Mayor Elizabeth Patterson and

Dear Mayor Patterson and Benicia City Council:

I am a licensed Civil and Structural engineer in California practicing engineering for the last 37 years and I have been a Benicia resident for more than 35 years. I submitted my written and verbal comments regarding this project on February 10, 2016 at the planning commission hearing. There was some discussion of my comments at the planning commission hearing of February 11, 2016 with Valero, ESA consultants and City Staff responding to some of the issues raised by me. Here is a link to the February 11 hearing video (there is no transcript of that hearing available yet): http://benicia.granicus.com/MediaPlayer.php?view_id=1&clip_id=10

Below I summarize my comments that were previously submitted, along with my paraphrasing of some of the Valero, ESA, and City Staffs' responses and my final clarifying notes to wrap up the discussion. These sections are prefixed with **R** and **RC** for clarity, and have different font color.

Figure 3-3

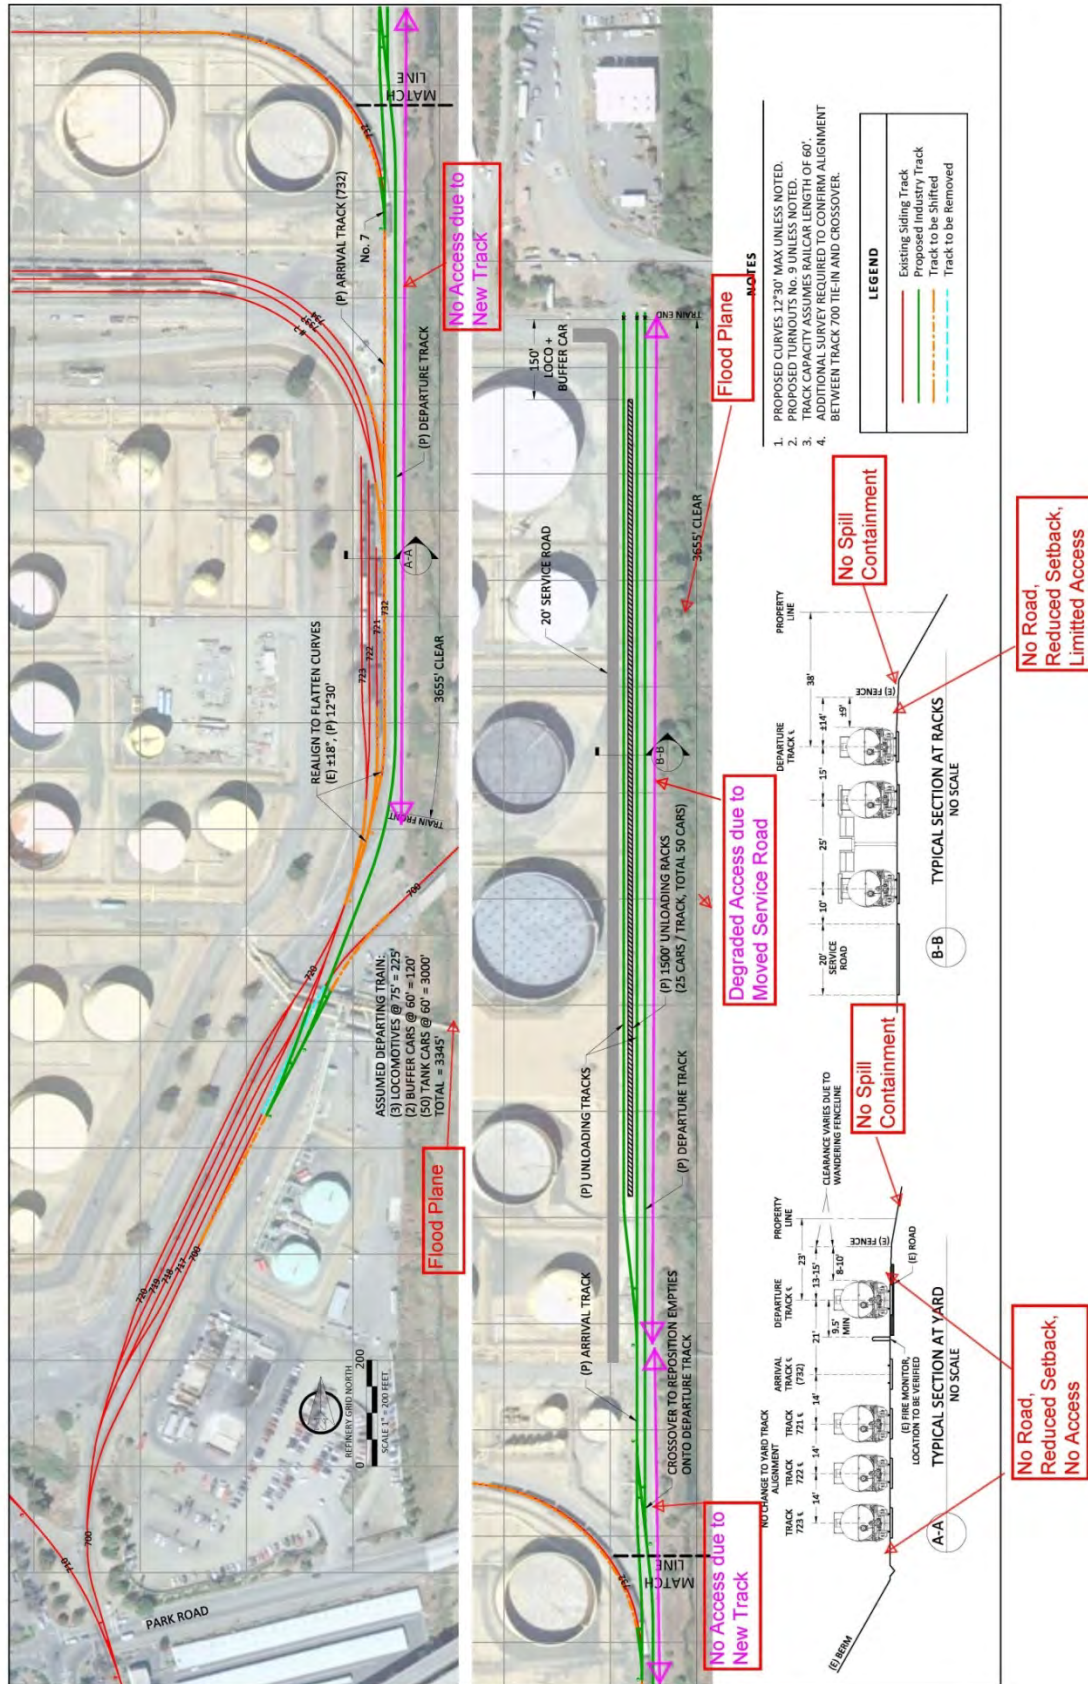
3. The proposed CBR project eliminates this service road and builds a railroad track in its place where a 50 car train could be parked over extended period of time every day and night, 365 days a year. Valero proposes to construct a 1900 feet partial replacement service road 60 feet away and parallel to the present road on its south-east (Figure 3-3 of DEIR enclosed at the end of this letter). Along this segment (Section B-B of Figure ES-3 of DEIR) there will be a substantial degrading of emergency vehicle access to the eastern most train (departure track) and the middle train, as well as the Sulfur Spring. Along the remaining 1755 feet segment (Section A-A of Figure ES-3 of DEIR) there is actually no emergency vehicle access at all where potentially up to 5 trains could be in an emergency situation with no access to them or to the Sulfur Spring banks to contain any hazardous spill or suppress fire/explosions.

We note that there are no retaining walls or barriers at this location on the drawings that we have seen. The latest drawing available (Dwg 89413, revision 01-08-16) in Sections A-A or D-D shows only an 8 inch high curb. Moreover, given the trains size and weight, we do not believe a 3 foot high wall will stop a train from tipping over. (See the attached Section A-A, where we have shown a 3 foot high wall and it is apparent even to non-engineers that this not a serious solution to prevent train tip over.

Figure 3-1 – Setback with defined bank (see exceptions Section 20-30.040.D.4.)

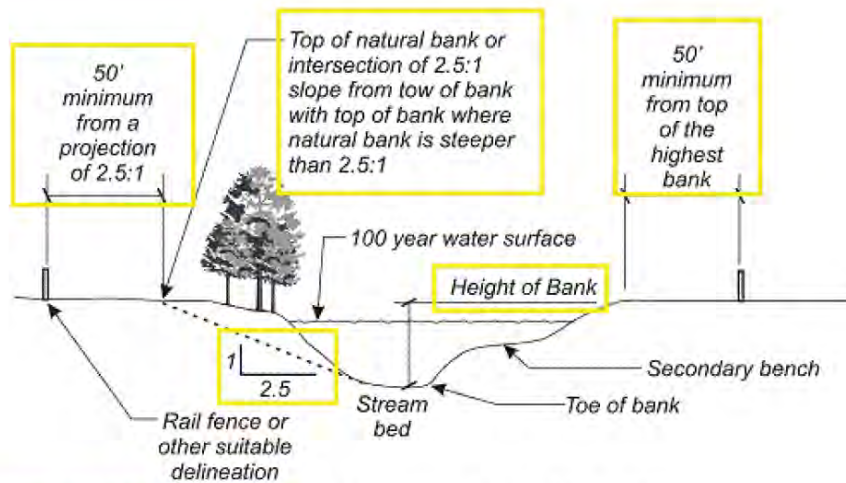
City of Benicia Municipal Code's section regarding the setback is very brief. This might cause ambiguity for some as to what really constitutes a "development", and what is the meaning of "top of the bank"? That is why I have enclosed at the end of this letter similar provision for the City of Santa Rosa, where "development" is defined in detail, and "top of the bank" geometry is graphically defined in sketches. Please note that roads and walls are defined as development and are prohibited in the setback. Also please note that the top of bank definition requires drawing a 2.5 to 1 line from toe of the stream bank to the ground surface.
